Level SRO Tier 1 Group 1 K/A# 027 2.4.30 Imp. RO 2.2 Imp. SRO 3.6

Recommend SRO Question #3 be deleted from the examination.

Condition 1 : Safety System Functions

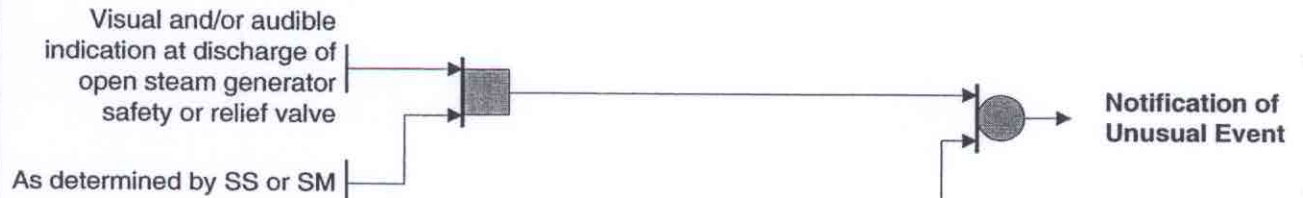
The information in the keyed answer stated that the pressurizer PORV has seat leakage and isolation was unsuccessful. However, there was no information provided that indicates whether the PORV opened to reduce RCS pressure. On the far left of Page 3 of F3-2, "Classification of Emergencies," Attachment 1 is the initial logic gate which reads: "PZR safety or relief valve opens and then fails to reseal." Since this condition is not met in the keyed answer choice, the described condition is NOT a NUE.

The other answer choices have been reviewed and are still incorrect for the reasons stated on the key. Since there is not adequate information to support a NUE declaration, this question has no correct answer and this question should be deleted from the exam.
